St. Jean de Brébeuf Catholic Secondary School

4-PAC PORTABLE CLASSROOM ADDITION

SITE PLAN &
OBC MATRIX

SITE PLAN
SCALE: 1:500

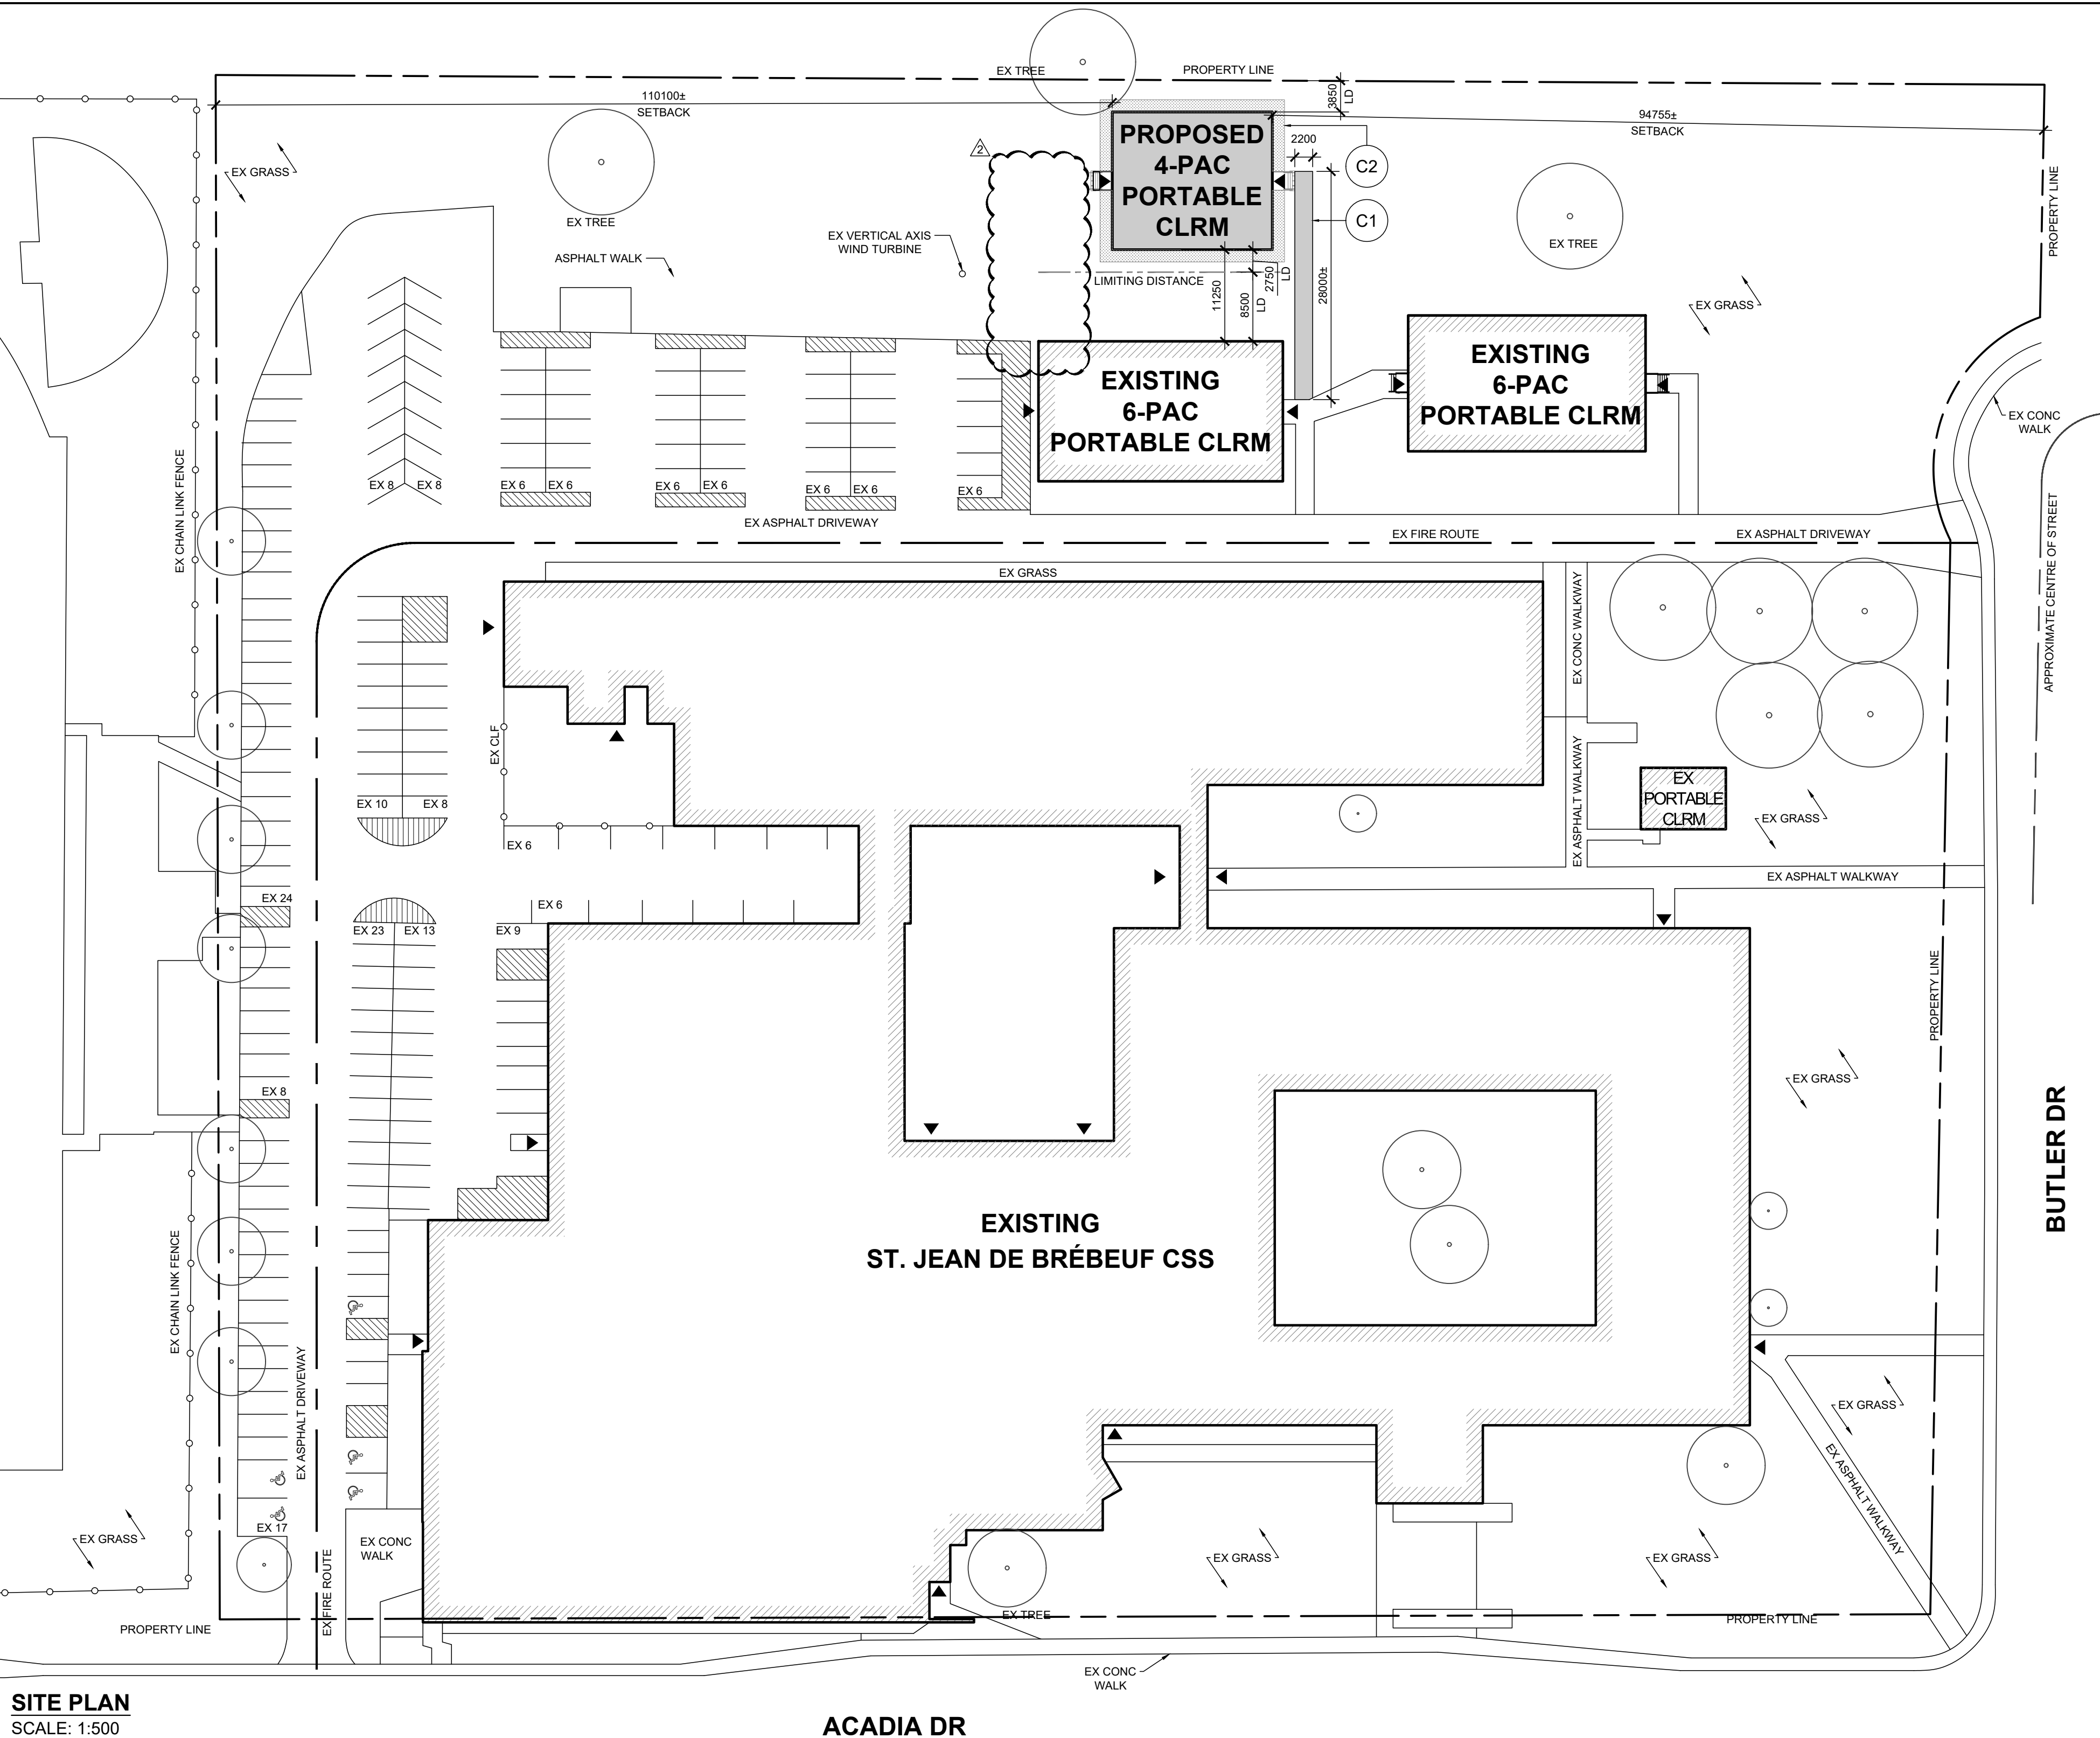
- Item 1** **DELETE** the new asphalt walkway along south side of the new portapack. Refer to attached revised drawing A1.00 Site Plan & OBC Matrix.
